PLANNING COMMISSION MEETING AGENDA REGULAR MEETING

5. PUBLIC HEARING – PRELIMINARY SITE PLAN REVIEW (File Number SP2021-0020) – Proposed Adler Cove (One Family Residential Cluster), South side of Long Lake, East of John R (Parcels 88-20-13-100-012, 88-20-13-100-014 and 88-20-13-100-025), Currently Zoned R-1C (One Family Residential) Zoning District

Project Name:	Alder Cove
Plan Date:	September 20, 2021
Location:	South of E. Long Lake, east of John R.
Zoning:	R-1C, One-family Residential District
Action Requested:	Preliminary Site Condominium Cluster Approval
Required Information:	Deficiencies noted.

Setbacks for non-cluster (underlying R-3 zoning) as compared to cluster development

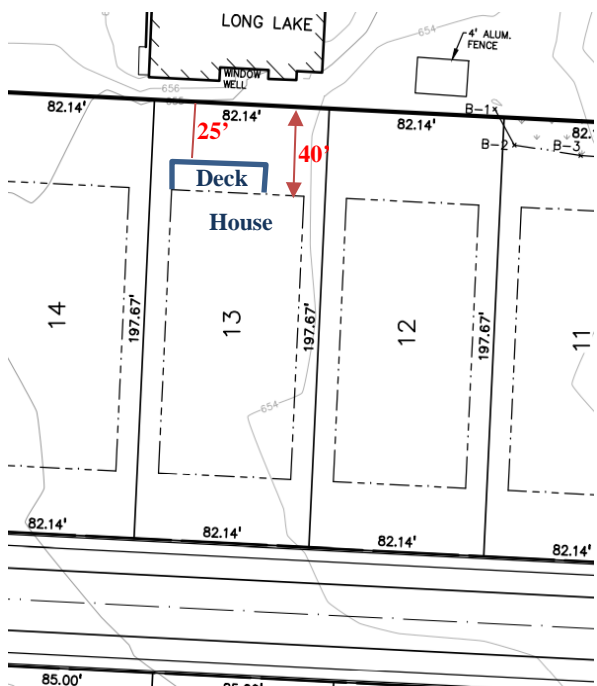
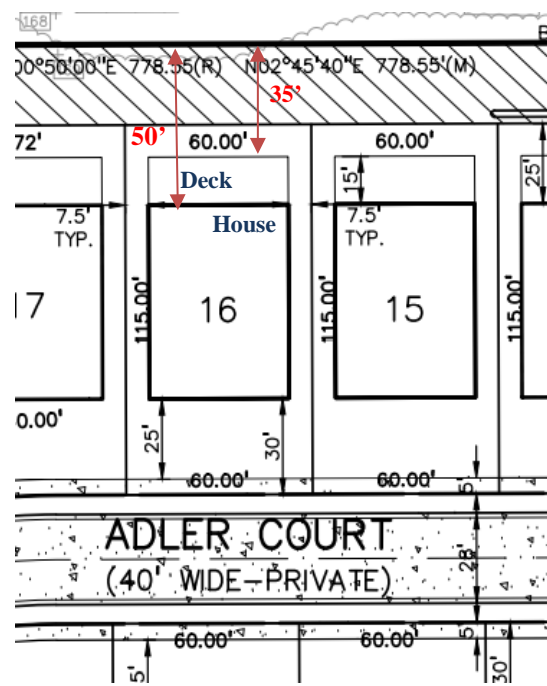
The applicant is showing decks on the rear of all properties. As set forth in Section 7.08.B:

The decks extend 15-feet from home and encroach 15-feet into the required 25-foot rear yard. Please note that provision 7.08.B was drafted for a conventional R 1 through R-5 lot that requires a 40-foot setback. Hence for a typical R-lot, the 40-foot rear yard requirement would allow a 15-foot deck and still maintain at least a 25-foot rear yard setback. However, due to the required additional perimeter setback required by the cluster provisions, the decks are further away from the northern property line via cluster than conventional layout. See graphic below:

Conventional R-3 layout, with decks 25-foot and house 40-foot from northern property line,

Proposed cluster layout with decks 35-foot and house 50-foot from northern property line

The City Council, based upon a recommendation from the Planning Commission, may waive the rear lot and perimeter setback provisions provided that the applicant has demonstrated innovative and creative site and building designs and solutions, which would otherwise be unfeasible or unlikely to be achieved absent this provision. The Planning Commission should consider the purpose and intent of the Cluster Development option in considering the setback deviations.
